Technical Bulletin			 Tesco Corporation 5616 – 80th Avenue SE Calgary, Alberta, Canada T2C 4N5 Tel: 1-877-TESCO-77 (North America) Tel: 1 (713) 359-7195 (AMSS 24-hour support) Tel: 1 (713) 359-7295 (International) Email: bulletins@tescocorp.com www.tescocorp.com www.tescoparts.com
No: TB095	Rev: 1	Date: September 19, 2014	
ECI and HCI Torque Bushing Clevises			
<input type="checkbox"/> Internal Use Only <input checked="" type="checkbox"/> External Use			
			<input type="checkbox"/> Mandatory <input checked="" type="checkbox"/> Recommended

BACKGROUND INFORMATION:

Figure 1: ECI/HCI torque bushing front plate

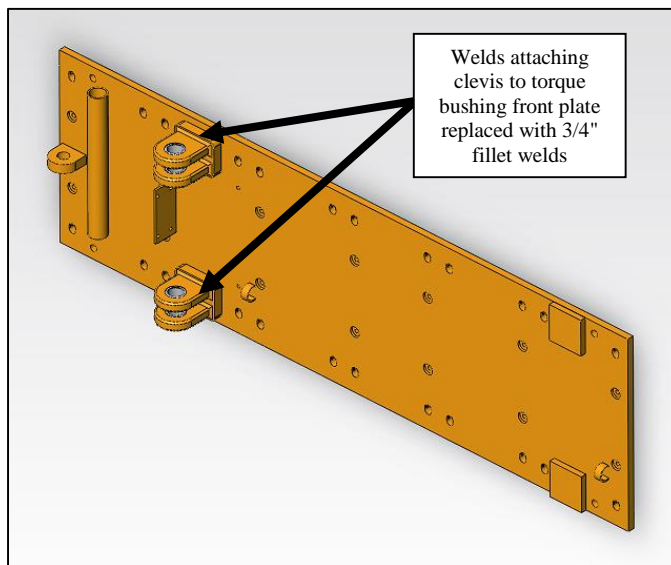
As the industry is demanding greater capacity and higher torque to drill long reach horizontal wells, the TESCO ECI and HCI Top Drive torque bushing clevises are exposed to more vibration and higher load than they were originally designed to handle. Consequently, TESCO is advising customers to increase the weld size of the torque bushing clevis to meet this higher demand. As a field retrofit procedure, TESCO is recommending to grind out the existing welds and replace them with a revised weld. A revised drawing of the torque bushing front plate (14728 Rev10) has been issued to assist in the rework of all affected units.

1. The welds attaching the clevises to the torque bushing front plate (14728) are to be fully ground out and replaced with 3/4" fillet welds (Figure 1) under an approved weld procedure for A514 grade material (Quenched and Tempered 100 ksi yield plate), as specified in the drawing of the front plate (14728 Rev10).
2. Ensure that the rework is performed by a qualified welder using an approved weld procedure specification suitable for A514.
